February 21, 2008

EA-08-046

SUBJECT: BYRON STATION, UNITS 1 AND 2 SPECIAL INSPECTION - DEGRADATION
OF THE ESSENTIAL SERVICE WATER RISER PIPING TO THE COOLING
TOWER BASIN 05000454/2007009(DRS) AND 05000455/2007009(DRS) AND
PRELIMINARY WHITE FINDING

Picture No. 5 – 0E SX Riser Pipe- June 14, 2007

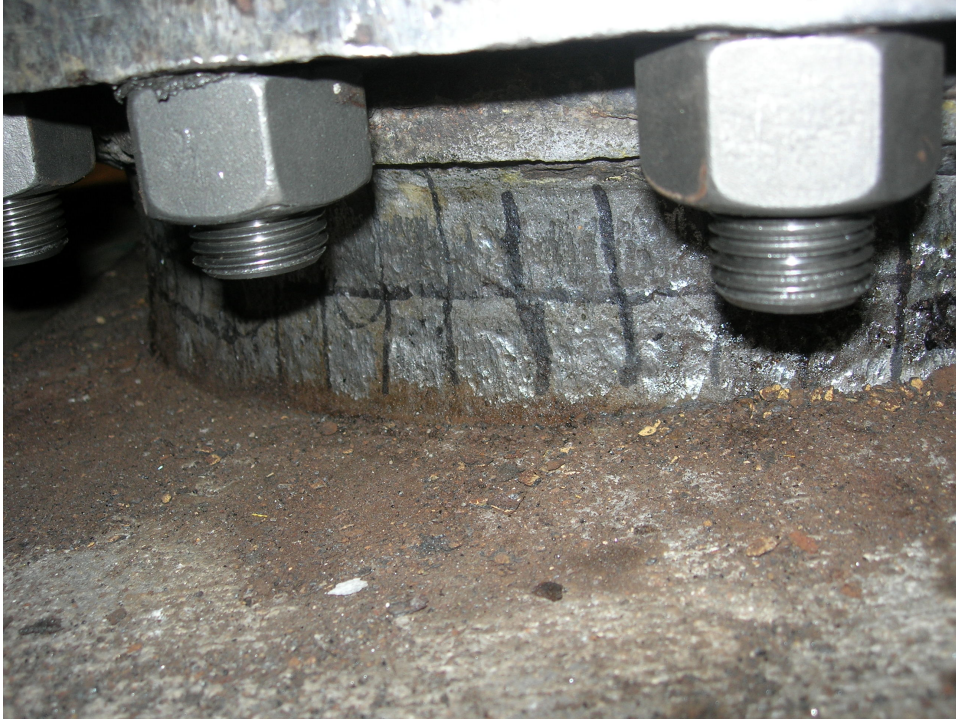
points approximately 1 inch in diameter (reference UT report 2007-005 and AR 00640363). The licensee recorded wall thickness measured at these two points (0.122 inch and 0.124 inch) that was substantially below the nominal pipe wall thickness of 0.375 inch. The licensee discussed the degraded OE SX riser pipe at the Plant Health Committee (PHC) meeting on June 25, 2007, and the PHC recommended repair of the degraded SX riser pipes, but no repair work was accomplished prior to the dual Unit shutdown. After shutdown, the team observed extensive corrosion present on the OE SX riser pipe.

On July 11, 2007, the licensee's design control measures failed to verify the adequacy of the design of the degraded 0E SX riser pipe, in that, the methodology and design inputs used did not include significant factors (e.g., thermal stress, compressive loads (buckling) and functional capability) which affected the structural integrity of this degraded riser pipe. Specifically, as documented in EC 366395, "Nonconformance Evaluation for Line 0SX97AE-24 Near Valve 0SX163E," the licensee failed to check the thermal stress in accordance with Equations 10 and 11 from the ASME Code, 1977 Edition, Section III, Division 1 Subsection ND-3600; failed to evaluate the compressive (buckling) loads present within the thinned SX riser pipe wall; and failed to check the functional capability in accordance with the site procedures that implemented UFSAR Section 3.9.3.1.3 requirements for Class 2 and 3 piping. Consequently, the licensee incorrectly concluded that the minimum pipe wall thickness was sufficient to meet Code allowable stress levels, and the degraded 0E SX riser was left in service until October 20, 2007.
